**EPA Superfund
Record of Decision:**

**Moffett Naval Air Station
(O.U. 5), Mountain View, CA
6/28/1996**

**MOFFETT FEDERAL AIRFIELD
FINAL OPERABLE UNIT 5
RECORD OF DECISION**

June 28, 1996

FIGURE 4
MOFFETT FEDERAL AIRFIELD
OU5 RECORD OF DECISION
OU5 PLUME

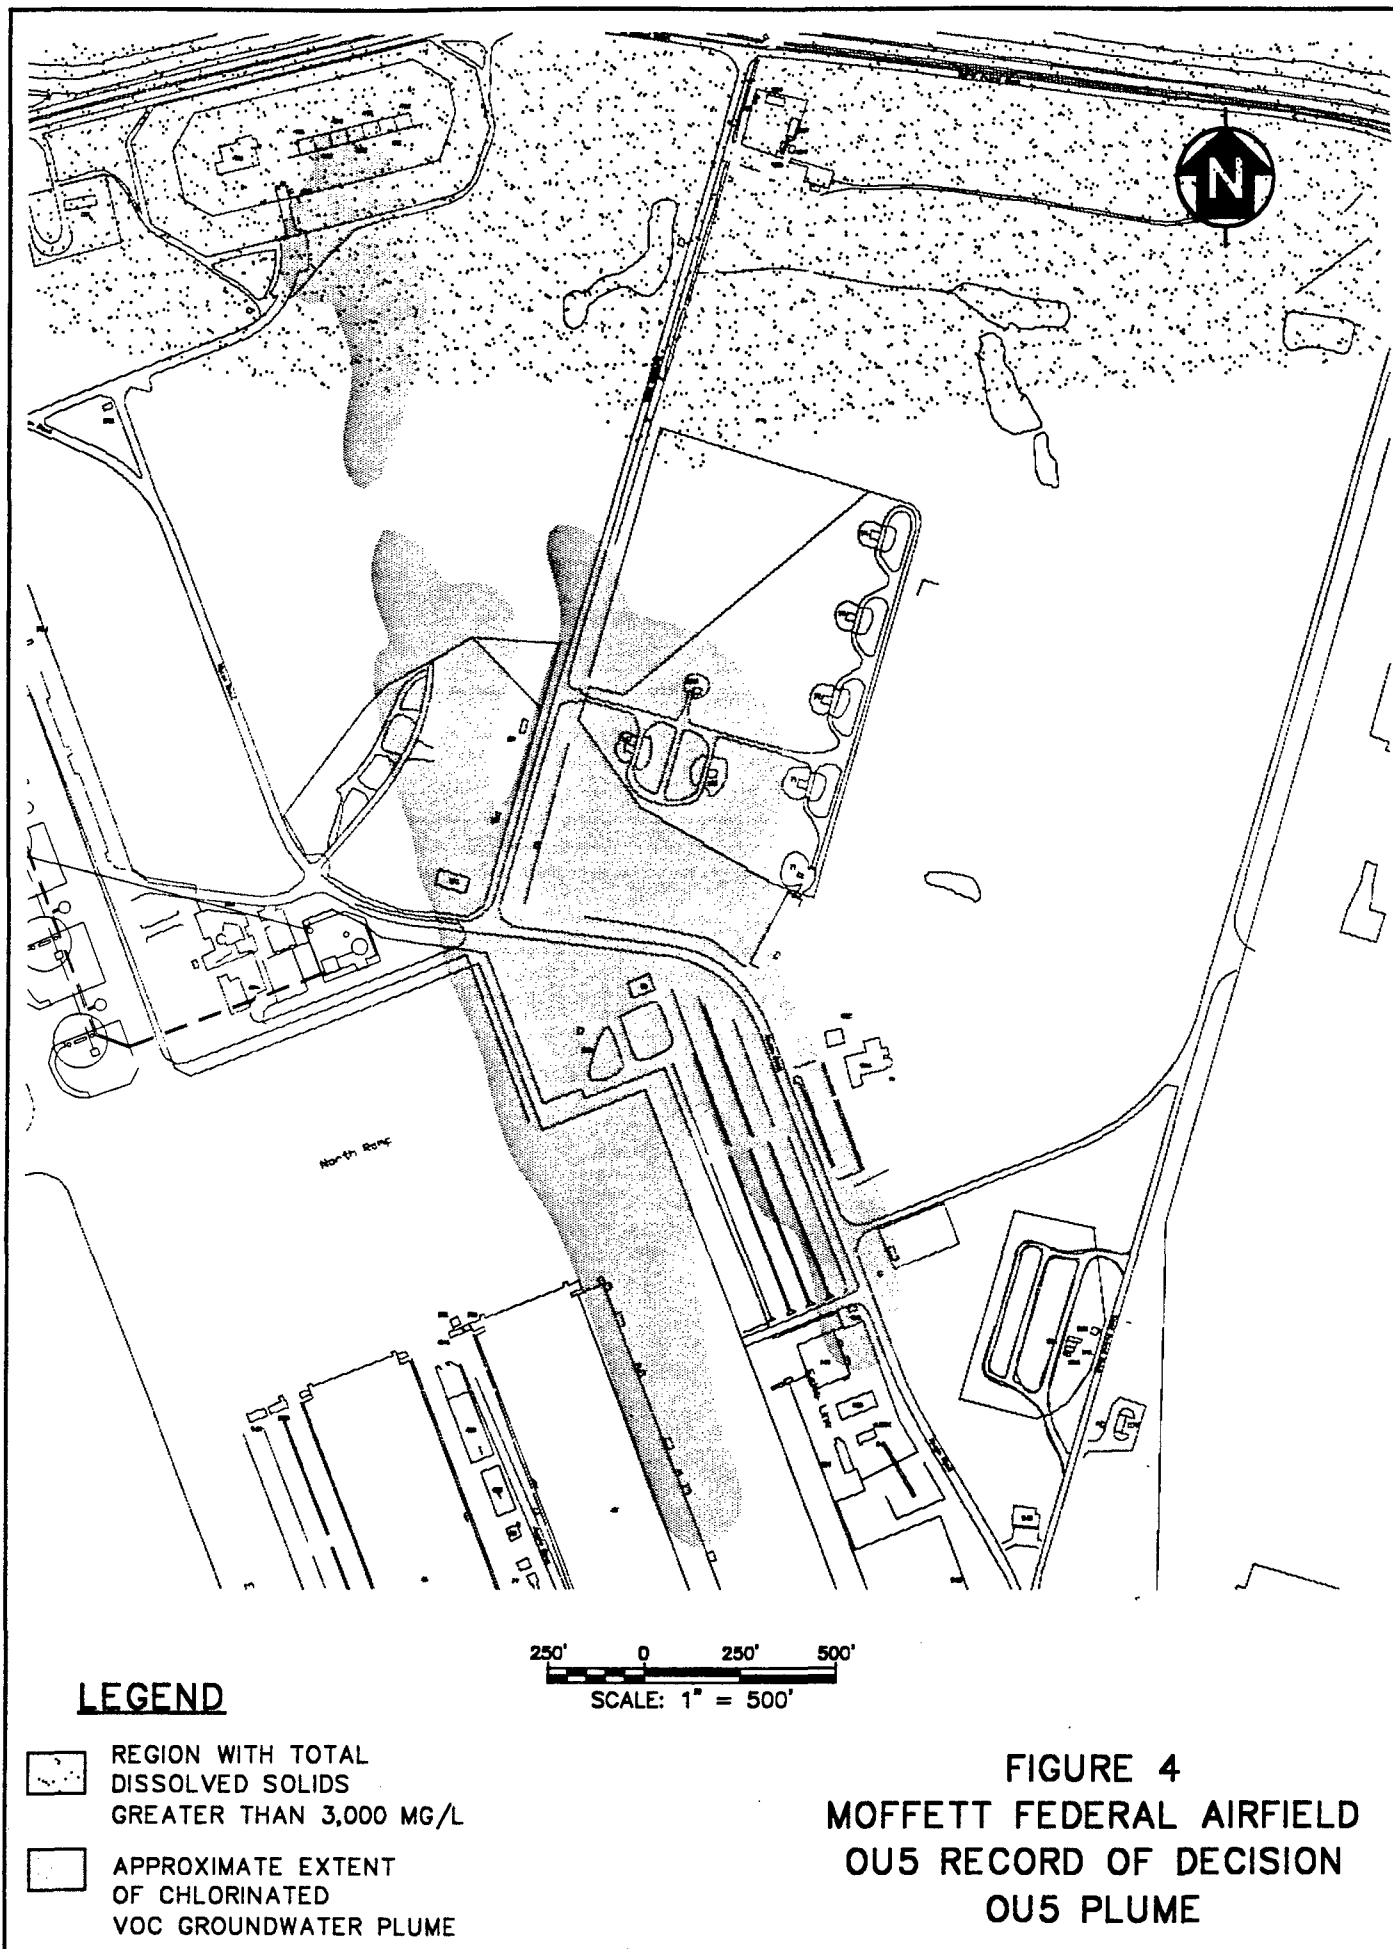
Comment 4. The Navy's characterization of OU5 chemical distributions is based on a relatively sparse data set. The Navy interpretation of these limited data to conclude that there are two separate plumes in OU5, separated by a narrow curving band of comparatively clean aquifer, is unrealistic and is conceptually inconsistent with the Navy's historical insistence that Moffett Field groundwater chemical distributions in westside aquifers are continuous over thousands of feet.

Response: Groundwater chemical data from at least seven monitoring wells (W3-6, W3-21, W3-24, WU5-3, WU5-4, WU5-6, and WU5-7) and four HydroPunch samples (CPTU5-13, -17, -18, and -31) indicate that two, separate contaminant plumes are present at OU5. The fact that the ratios of contaminants within the two OU5 plumes are distinctly different further supports the division of the plume areas. The Navy believes that the data at OU5 are adequate to move forward in selecting the cleanup technology. Additional data to confirm chemical concentrations and subsurface sediment distribution may be collected during the remedial design to optimize system effectiveness. Cleanup of COCs in OU5 will occur wherever groundwater is a potential drinking water source.
